solo AIRCRAFT ENGINES GMBH Industriestrasse 9 D-71069 Sindelfingen	Service Bulletin E.237 – 4 Electric Propulsion system 8000 Series	Seite 1 von 4
---	--	---------------

Engine type: Solo 8000 / 400 and Solo 8000 / 401

Subject: System freeze due to malfunction and resulting in possible constant power output

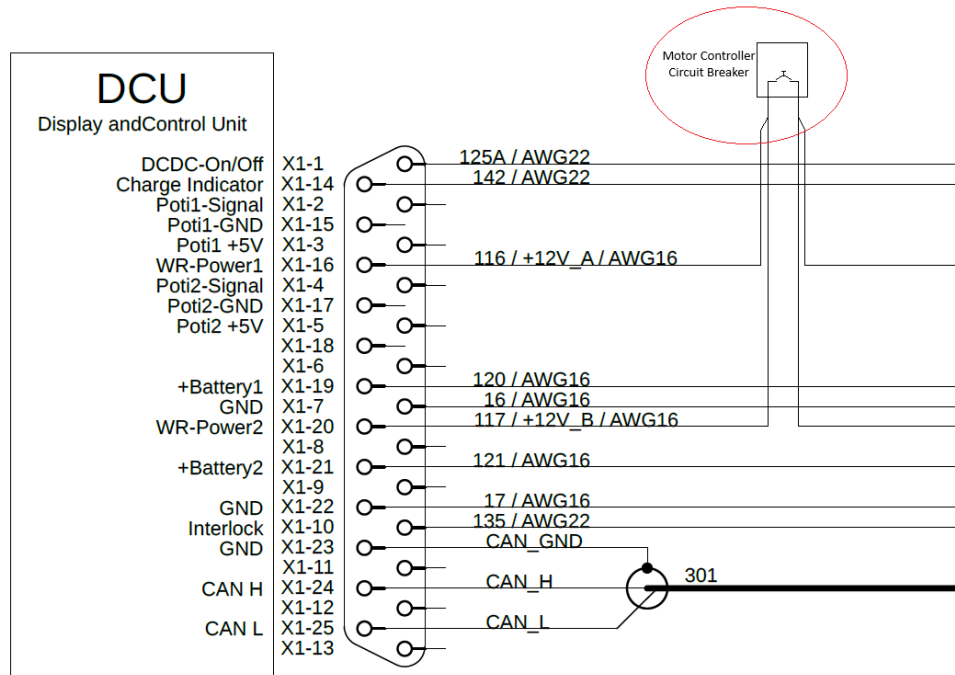
Action 2: In case of an electronic switching device:
 Modify the wiring according to the following wiring modification between the DCU and the motor controller:

Install a 4A or 5A slow fuse circuit breaker at the panel

Install the following label at the circuit breaker:

RES MC

In case of any unpredictable motor operation,
 pull the RES MC circuit breaker.
